Dwyer Road, Reading Non-material Amendment

August 2025

Report presented by **HTA Design LLP**
In association with **Reading Borough Council**
Status **PRELIMINARY**
Issue **Rev B**
Issue Date 13/08/25
File name **RBC-DRR_HTA-A_RP021**
Author **PCM/KDU**
Checked by **PCM**
Approved by **PCM**

The NMA relates only to amendments proposed to Block A.

Upper Floor Plan (NTS)

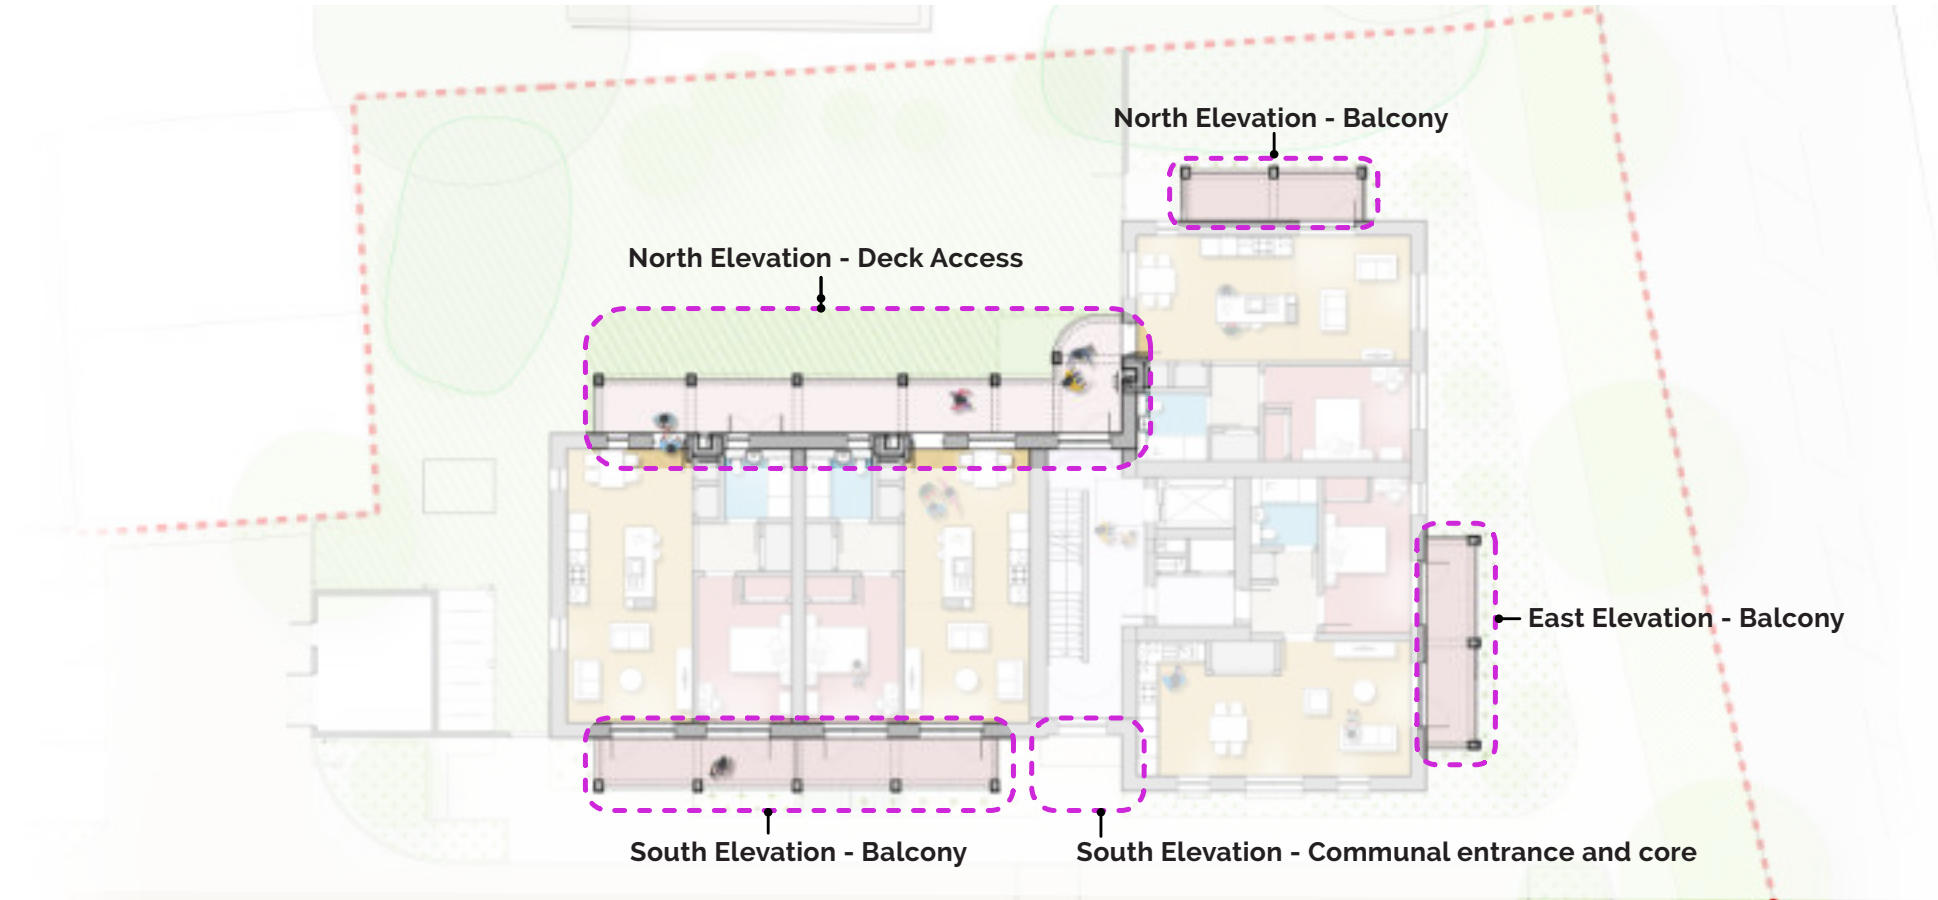
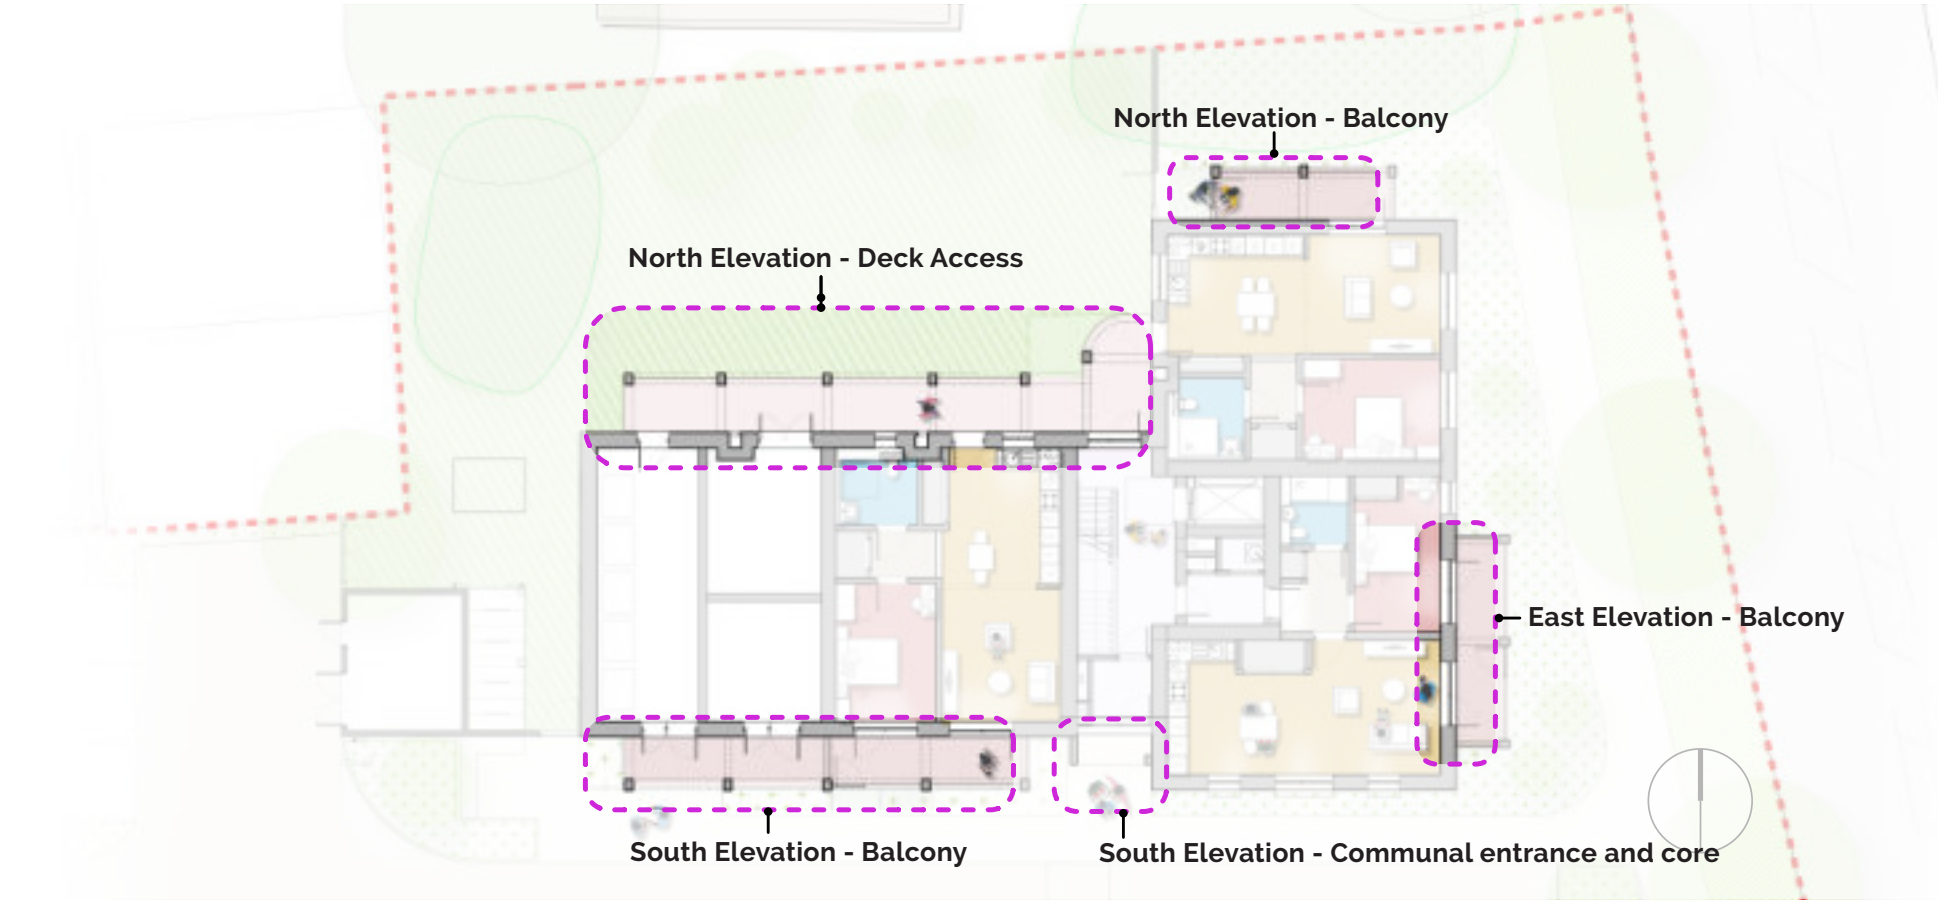
- The material of the deck access and balcony structures, highlighted in the adjacent diagrams.
- Update to 3 no. communal core windows to omit julliette in preference for opening lights, with fixed panes below
- Update to extent of RWPs with hoppers at final roof level
- Update to communal front entrance door component, to reduce width of component and introduce brick wall in lieu of fixed blanking panel
- Update to communal entrance canopy to include material change to match deck/ balcony in steel
- Update to reduce service risers and associated door access from 2 no. Risers to 1 no. Risers on northern deck access elevation
- Minor updates (maximum 1 brick dimension) elsewhere to adjust window and door setting out, as plans have been developed in more detail.

Block A - South Elevation (NTS) **(Consented)**

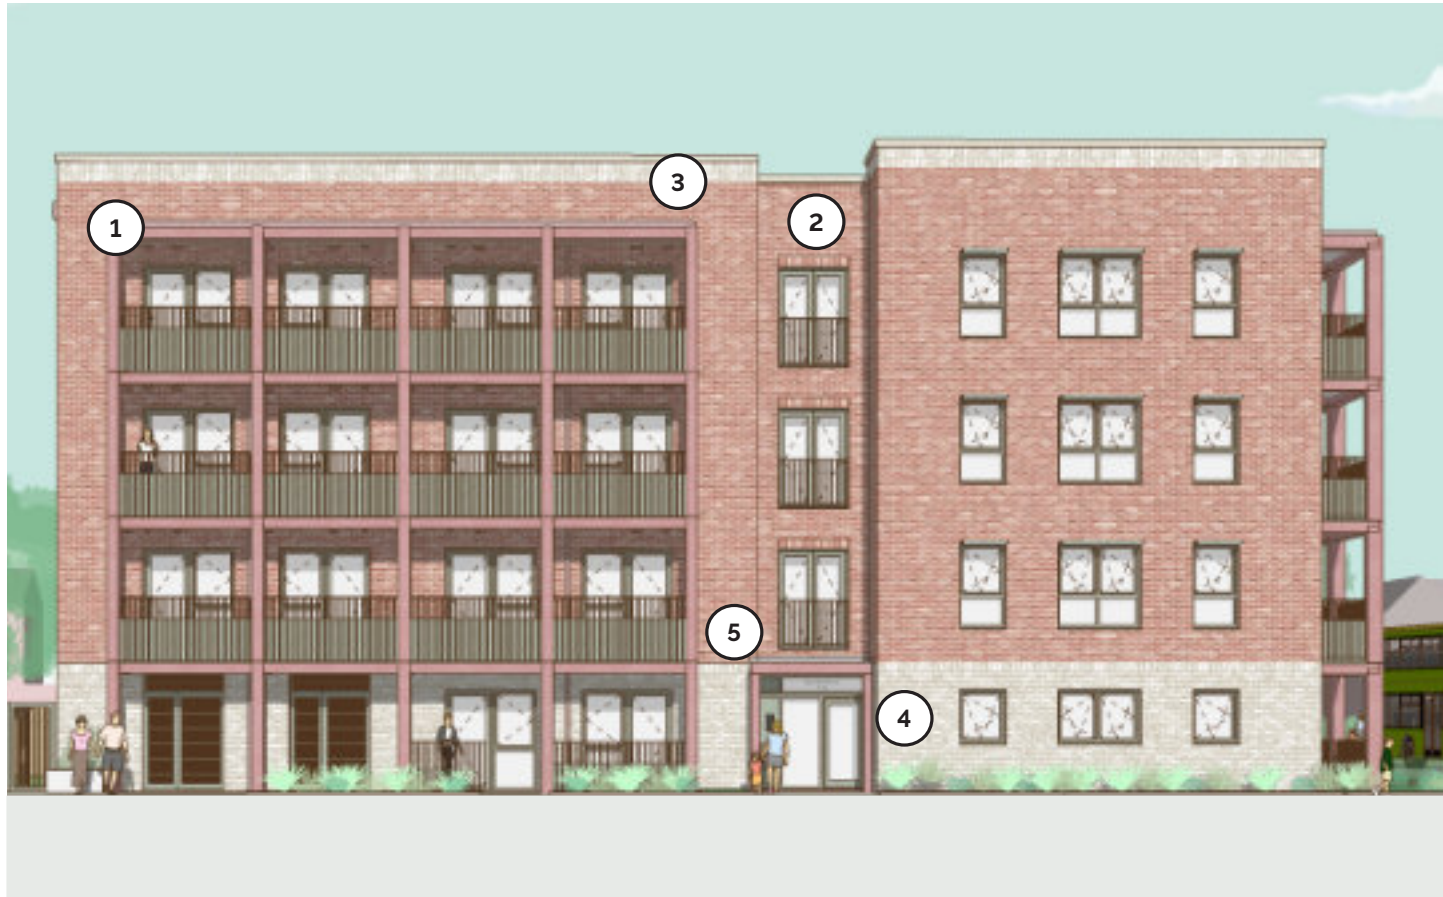
The material of the deck access and balcony structures

- Description:** Change from pigmented pre-cast concrete to painted steel
 - Reason:** Concern that bespoke detailing is not readily achieve on such a small scheme, and that batching pigmented pre-cast concrete may not be consistent across the elevations
- 2

Communal core windows amended

- Description:** Replace juliette style windows with opening lights with fixed transoms below
 - Reason:** To allow residents to control communal glazing, and improve safety in doing so by omitting full-height glazing
- 3

Rainwater goods updated.

- Description:** Rainwater pipes extend to include hoppers at roof level
 - Reason:** Revised to account for detailed design of roofing insulation
- 4

Communal front entrance door component

- Description:** Width of component reduced, brick wall incorporated in lieu of fixed blanking panel
 - Reason:** to provide adequate wall width to conceal services behind and improve thermal performance with standard masonry wall build up in lieu of spandrel panels.
- 5

Communal entrance canopy amended

- Description:** Pre-cast entrance canopy proposed to change to painted metal
 - Reason:** to match the material change to the balcony/deck structures elsewhere
- 6

Reduction of service riser doors

- Description:** Reduction of 2 no. service risers and doors on the deck access elevation to 1 no. riser and door.
 - Reason:** Design development of the MEPH designs has consolidated services to a single riser

Burghfield Road looking southwest

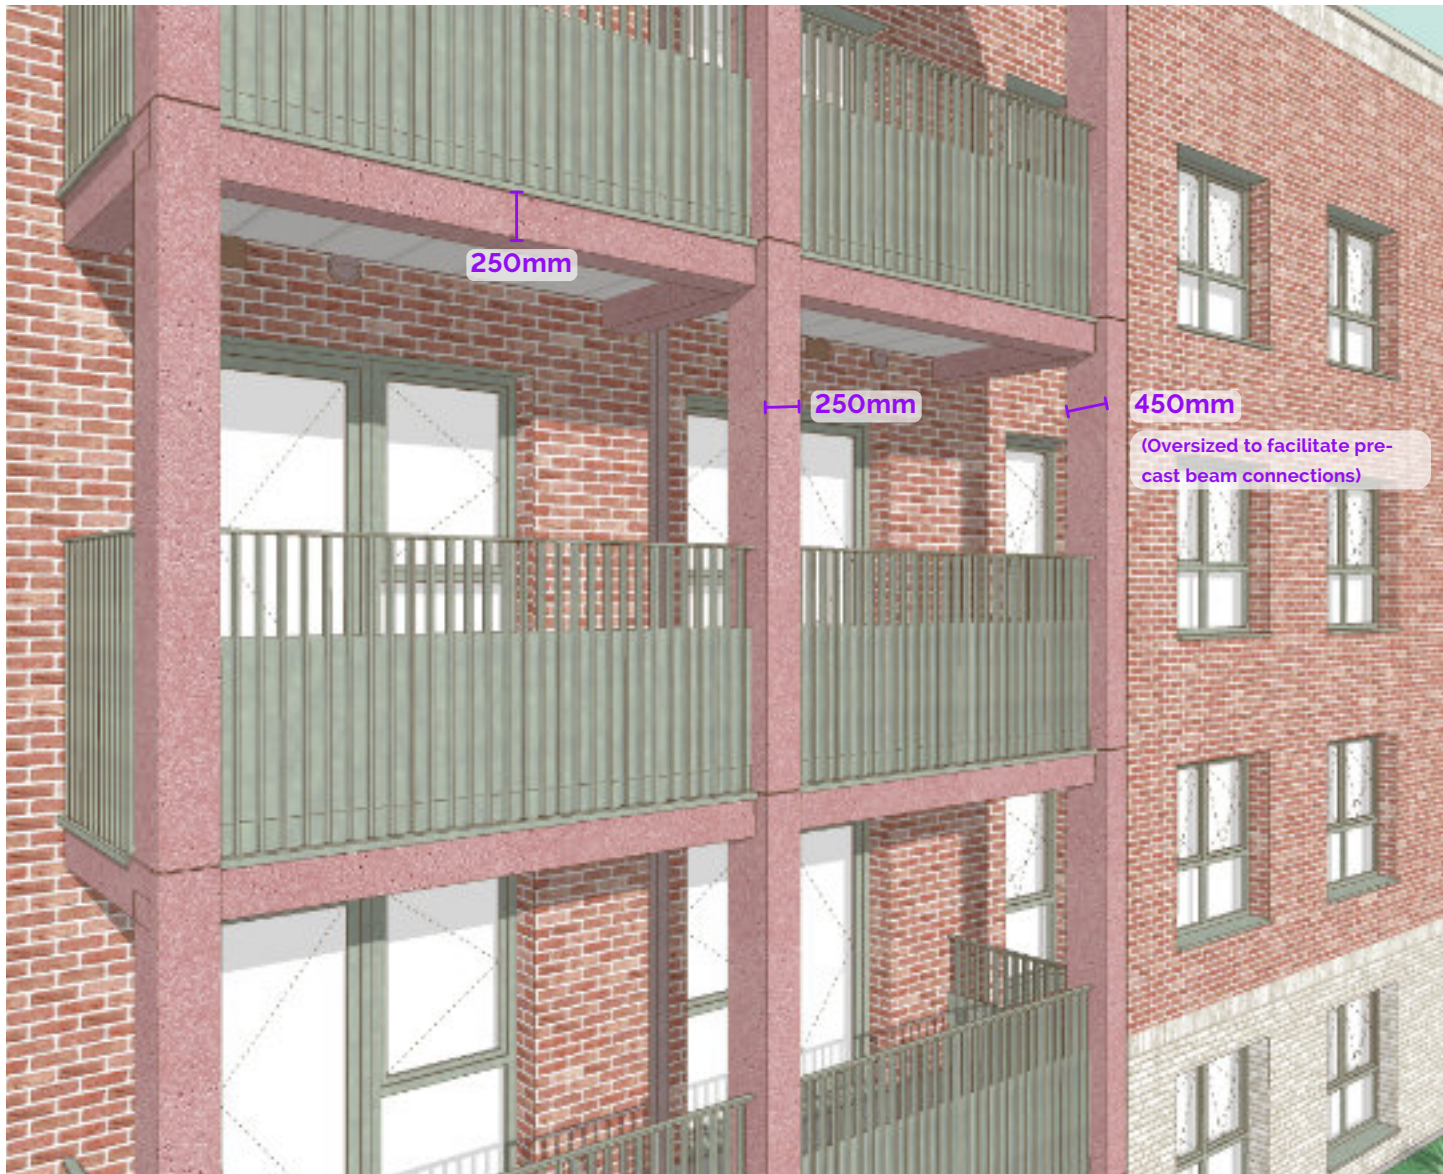
The intention is that the proposed change from pre-cast to metal finish on the balcony/deck access design, will tie into the wider site material palette which include metal standing seam roof to the terrace houses.

Final material selections and colours will be reviewed and selected as physical samples, and submitted for external materials planning condition discharge.

Oblique View - Painted steel balcony structure (**proposed**)

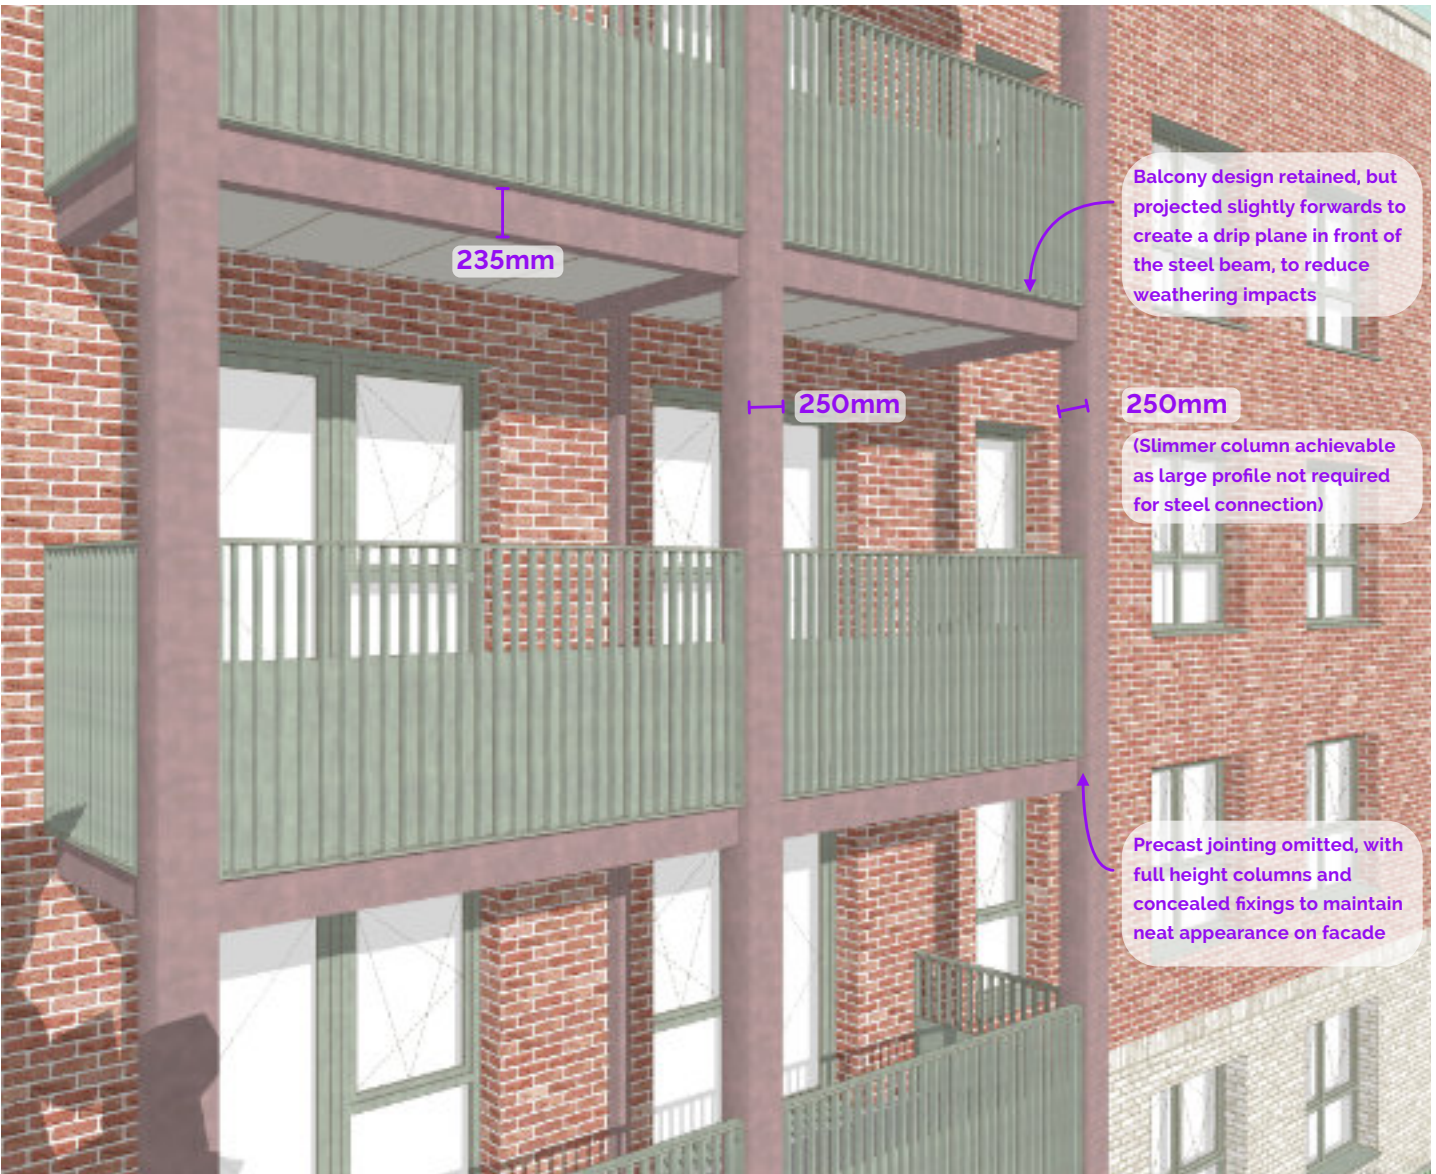
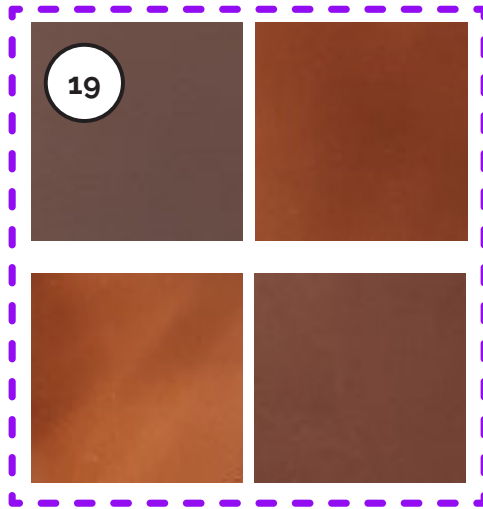
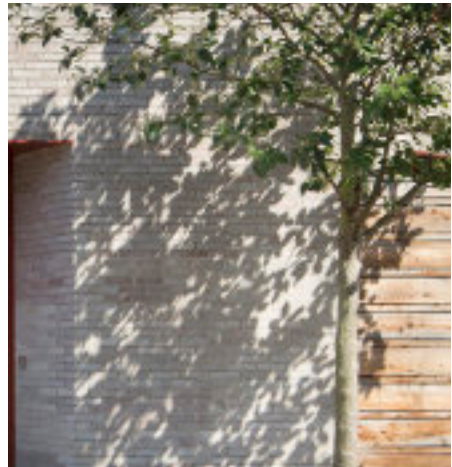
The proposed amendment to the balcony/deck access affects only the main "frame" of the structure;

- The steelwork is designed to replicate the dimensions of the precast design, retaining the same proportion and impact on the main facades, with reductions where appropriate or less visible.
- Columns will be constructed as full height elements with no joints, with beam connections intended to be discreetly located, on the 'interior' elevation, concealed from street facing elevations
- The general arrangement setting is out maintained, so that balconies and decks achieve the same

- amenity and access space as previously consented proposals.
- The balustrade proposed is retained as previously designed, with a slight projection in front of the steel beams to ensure good weathering run off, to help maintain the future appearance of the building
 - The steel structure allows the balcony and deck to retain the thermally broken design - separating it from the main building envelope, improving the thermal efficiency of the homes

Steel colour choices (Proposed)

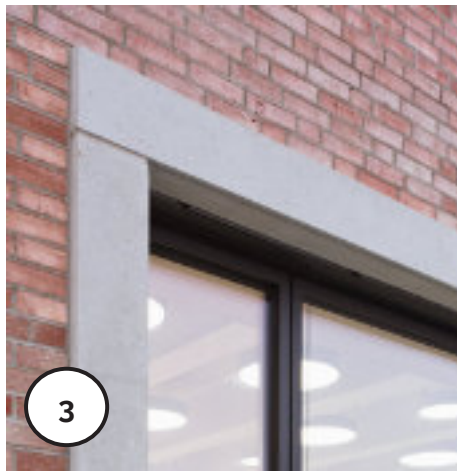
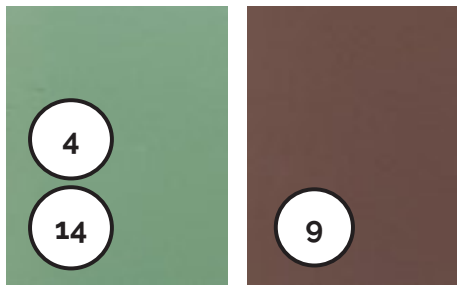
- The consented materials were selected to create a soft, domestic architecture that ties into the existing colourways of the Reading vernacular
- The materials proposed remain unchanged, with the exception of the pigmented pre-cast elements, which are to be replaced with painted steel.

- The pre-cast elements were intended to give a high quality finish, that was subtly distinct from but complimented the variegated red brick (1) palette, creating variation and interests.

- The colour selection for the steel work must therefore be contrasting but sit within the red/ brown palette as previously established (1/9)
- As noted in the street views, there is opportunity to select a metal finish that will tie into the final material and colour selection for the metal standing seam roofs specified for houses (9)

- A sample selection for (19) is suggested in the adjacent imagery.
- The final colour choice will be submitted as part of the external material planning condition discharge.
